Rampion 2 Wind Farm

8.54 Applicant's Response to Examining Authority's Written Questions – Fish and Shellfish Appendix H: Appendix H Noise Thresholds for Black Seabream (tracked)

Date: July 2024
Revision A

Application Reference: 8.54.1

Figure 2-1: Piling exclusion zone for the piling of monopiles, with 20dB reduction (Unwtd 135dB SELs)

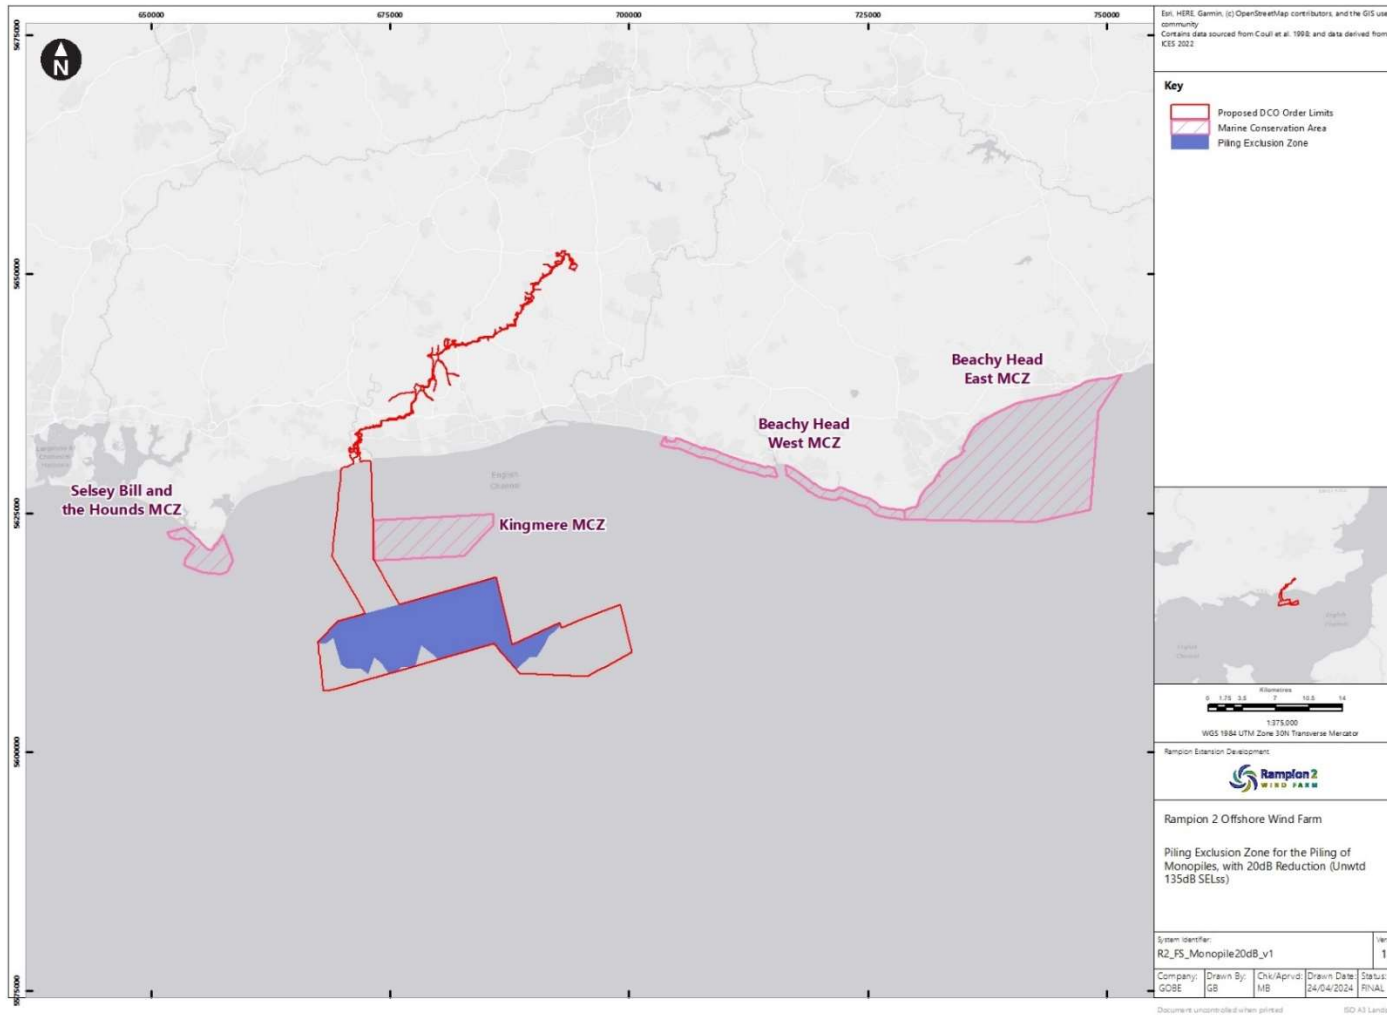
- 1.2.2 The areas available for piling multileg and monopile foundations on the basis of achieving a 135 dB SELss threshold are clearly shown in figures within this document, which have not required updating from the original version submitted a Deadline 3 [REP-051], specifically:
- Figure 2-1: Piling exclusion zone for the piling of monopiles, with 20dB reduction (Unwtd 135dB SELss); and

- 2.2.9 As evident in Figure 2-1 and Figure 2-2, the piling of monopile foundations with 20dB mitigation results in a substantially larger piling exclusion area in the northern section of the offshore array area for the 135dB SELss threshold in comparison to 141dB SELss. Due to the reduced hammer energy when piling multileg foundations, compared to that of monopiles, the impact ranges are smaller under the same mitigation scenarios, therefore the defined piling exclusion zones are also smaller (Figure 2-3 and Figure 2-4), though again the use of the 135dB SELss behavioural threshold (which is not applicable for a noisy environment such as the English Channel) to inform the zoning exercise has led to the definition of significantly larger piling exclusion zones than those defined using the 141dB SELss threshold. The Applicant highlights that the exclusion zones resulting from the 135dB SELss target noise level, which encompass the majority of the western array area, will have significant implications on the mitigation measures proposed in the **In Principle Sensitive Features Mitigation Plan [REP1-012]** (updated at Deadline 3), and consequently the piling programme. Such implications are detailed in Section 2.4 below.

- 2.3.4 The proposed mitigations from March through to June, as detailed in the **In Principle Sensitive Features Mitigation Plan [APP-239]** can be applied if they are defined using the 135dB SELss threshold, with a 20dB noise abatement. However, it should be noted, that whilst the piling exclusion area resulting from the implementation of the 135dB SELss threshold (as opposed to the proposed 141dB

Figure 2-2: Piling exclusion zone for the piling of monopiles, with 20dB reduction (Unwtd, 141dB SELss)

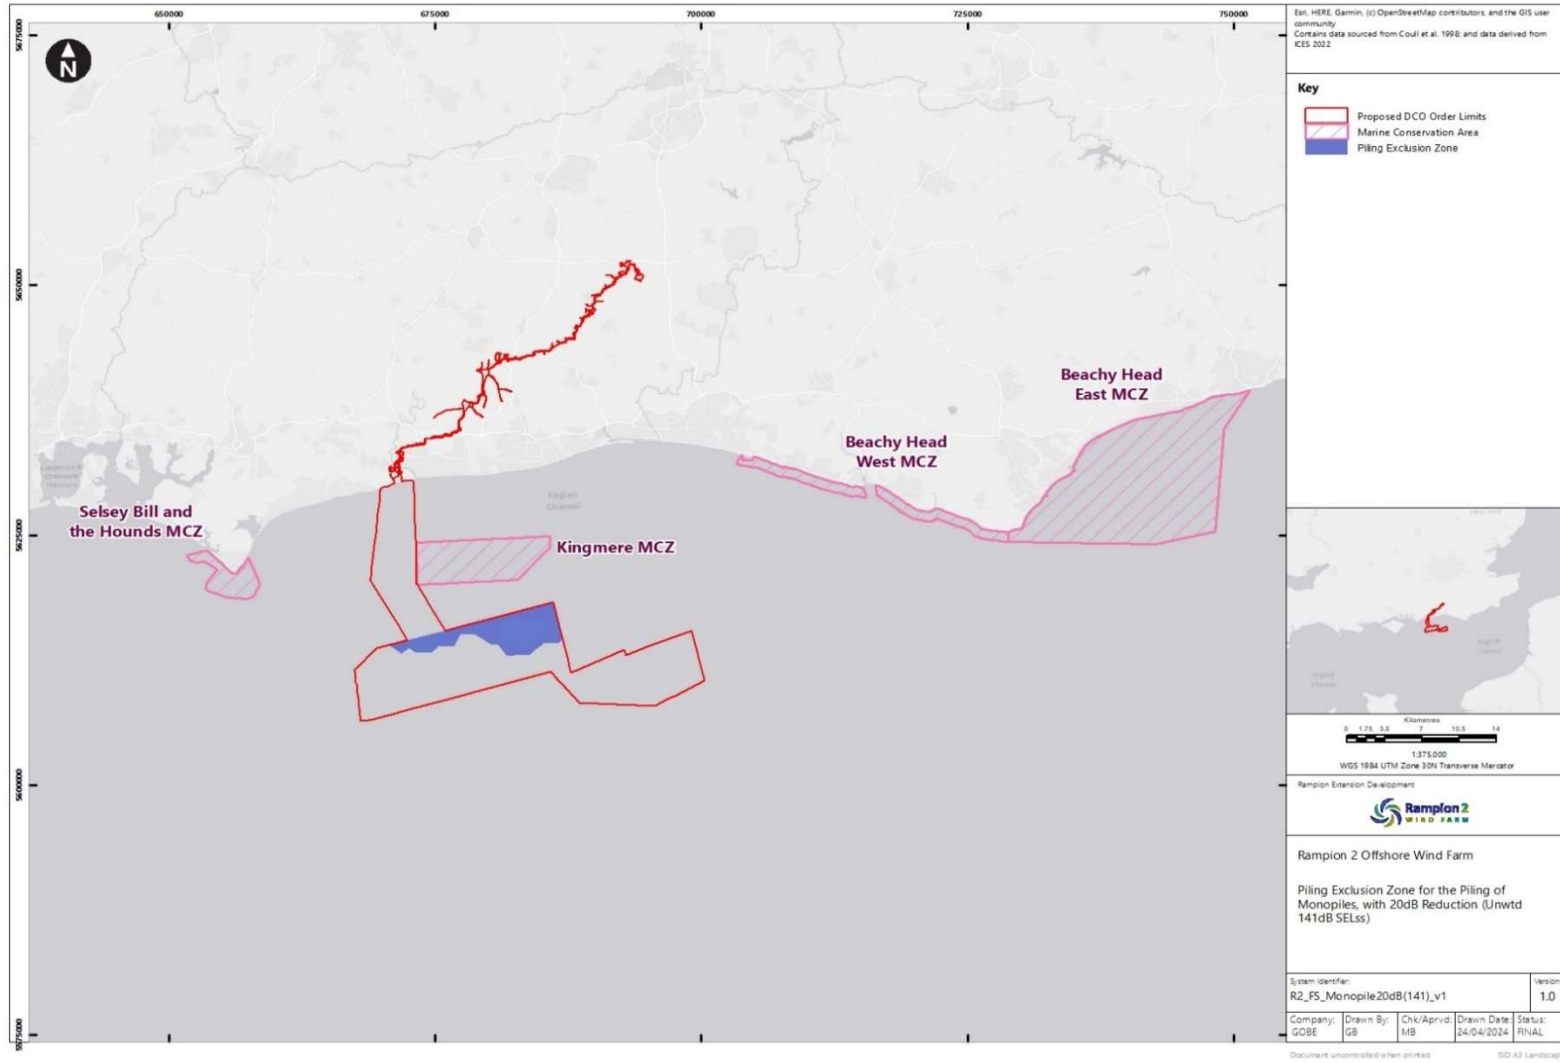
threshold) increases the exclusion zone across a relatively small part of the eastern array area (as evident in Figure 2-2 this still has significant issues on the piling programme for the project. Such implications are detailed in Section 2.5 of this clarification note.

Figure 2-3: Piling exclusion zone for the piling of multileg foundations, with 20dB reduction (Unwtd 135dB SELss)

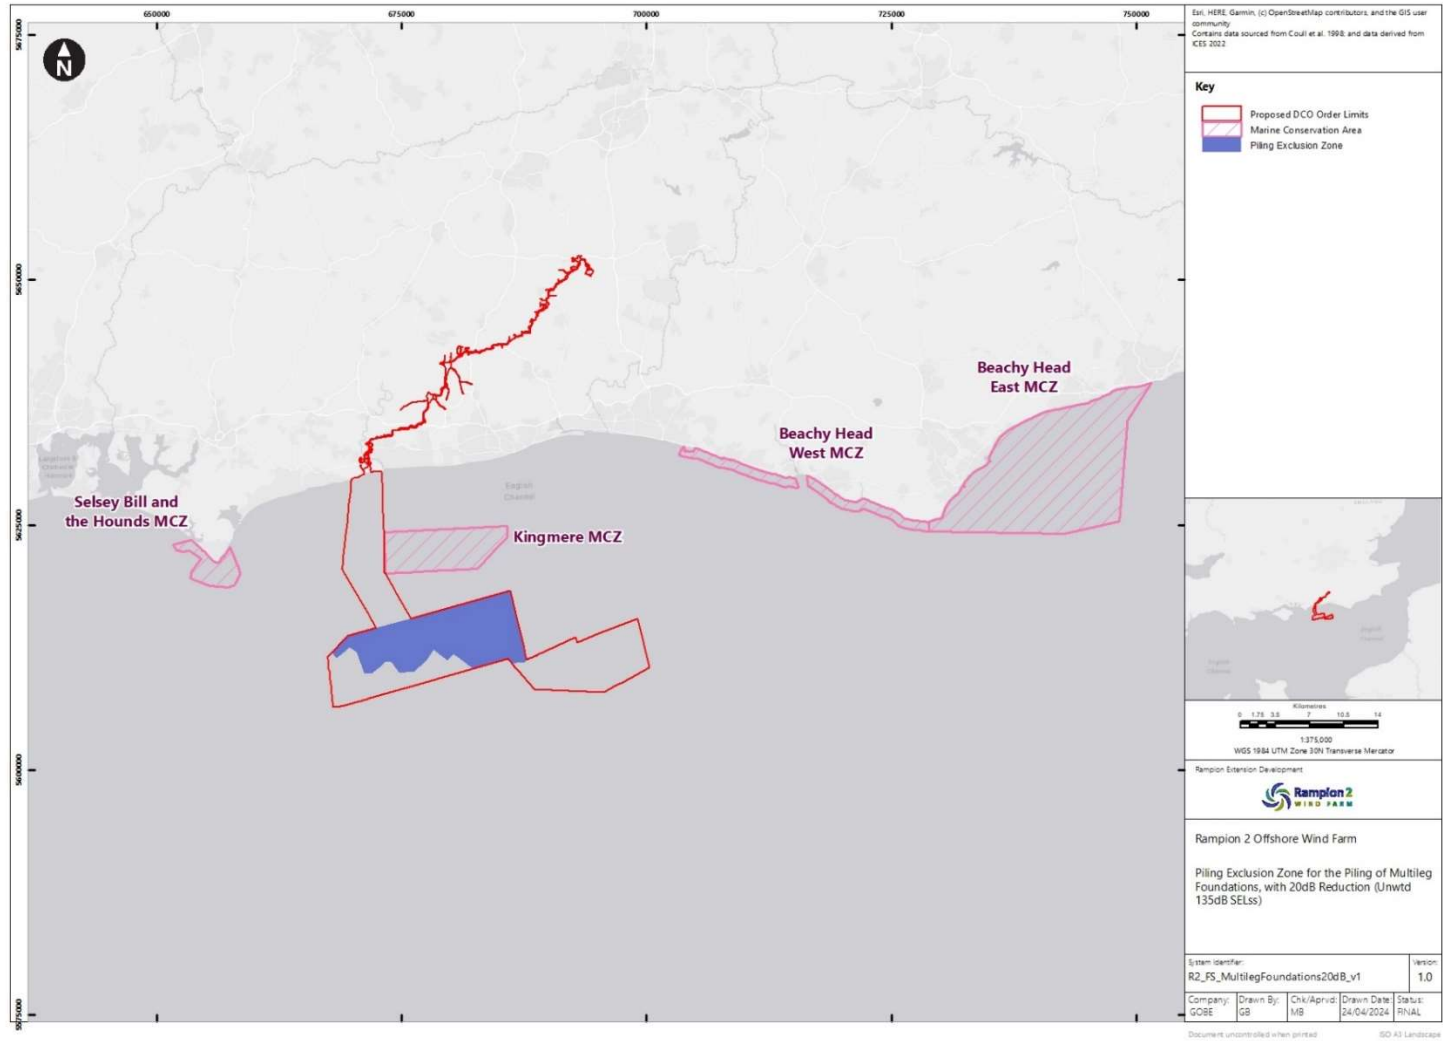
- Figure 2-3: Piling exclusion zone for the piling of multileg foundations, with 20dB reduction (Unwtd 135dB SELss).

- 2.2.8 It is clear from Figure 2-1 to Figure 2-4, to achieve a level of received noise no more than 135dB SELss at the Kingmere MCZ site, the piling of multileg or monopile foundations with the implementation of DBBC + PULSE or MNRU hammer mitigation (20dB mitigation) results in significant piling exclusion zones being required across the western portion of the array area.

Figure 2-6: Illustrative sequencing of piling activities

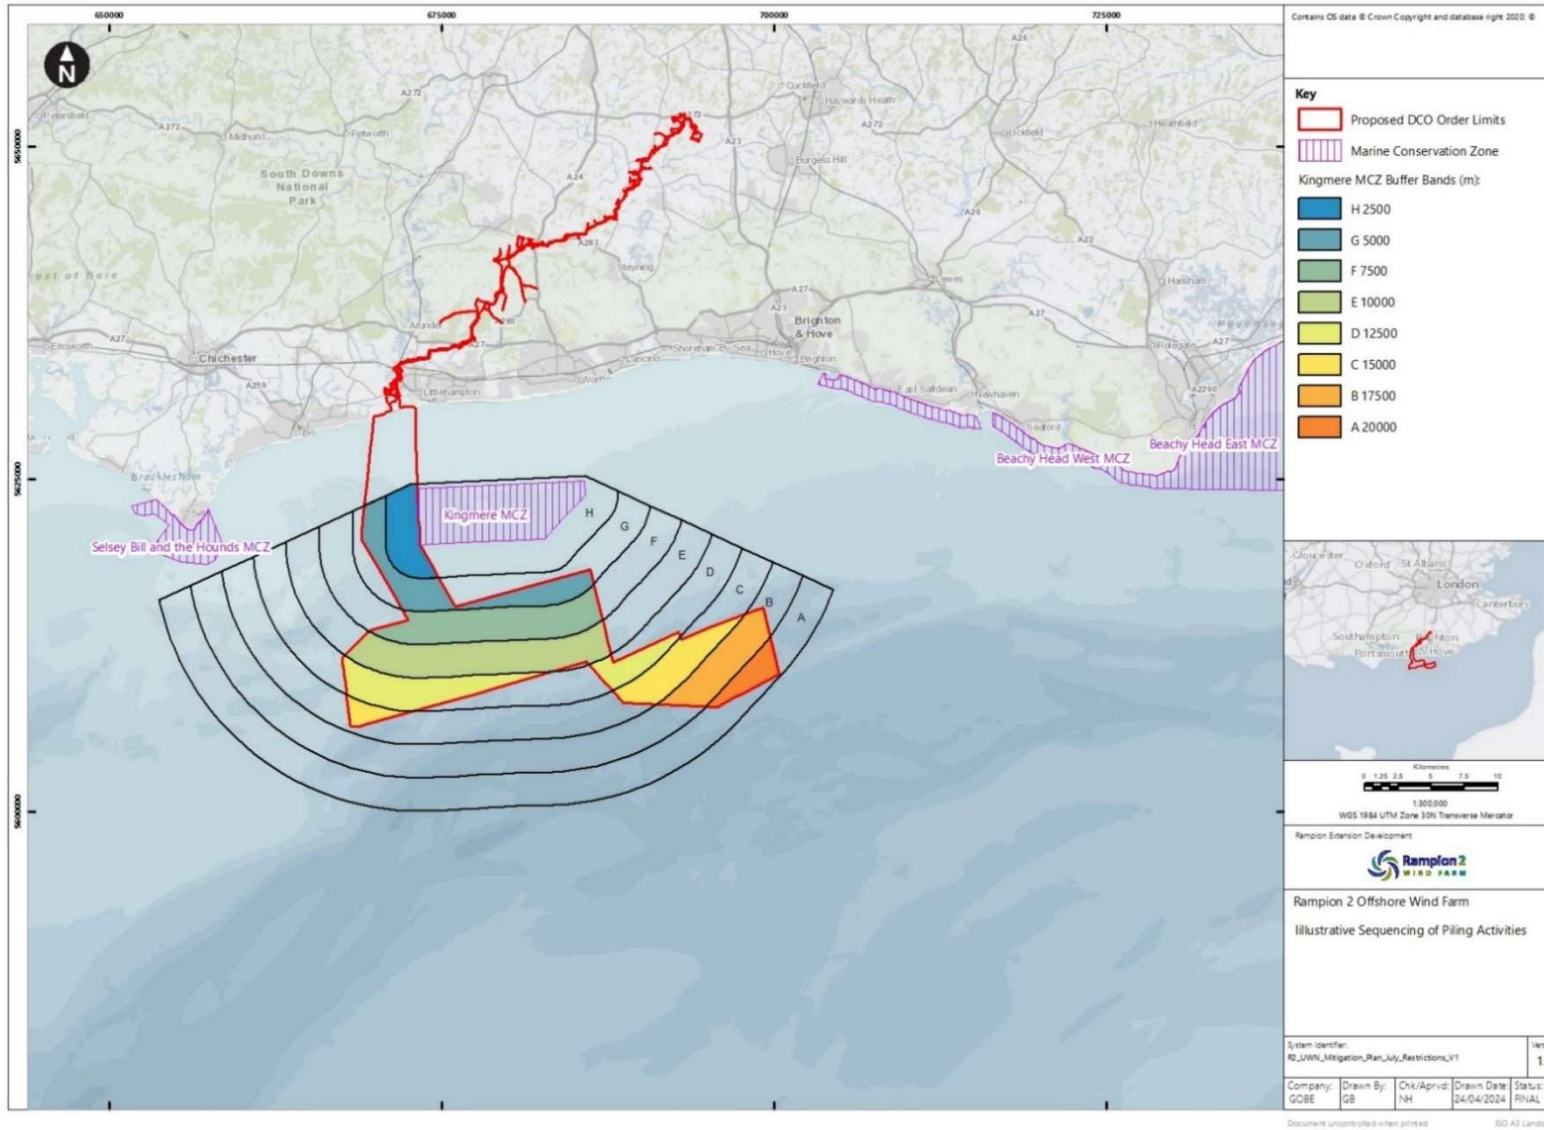
- 2.3.3 A zoning approach will also be implemented, with piling in the eastern area commencing in the southeast corner (area furthest away from the Kingmere MCZ) (band A buffer, as illustrated in Figure 2-6), and progressing across the array as piling operations continue (into band B, then C etc.).

- If piling in the western part of the offshore array is to be undertaken, foundation installation will be conducted using the combination of a low noise hammer technology and DBBC.
- Piling activities in the western part of the array will also be subject to a sequencing plan such that piling in July will commence at locations of the western part of the Array furthest from the Kingmere MCZ. Piling will commence from the pile locations in the furthest south-west corner of the western part of the Array (commencing in the band C buffer shown on Figure 2-6).
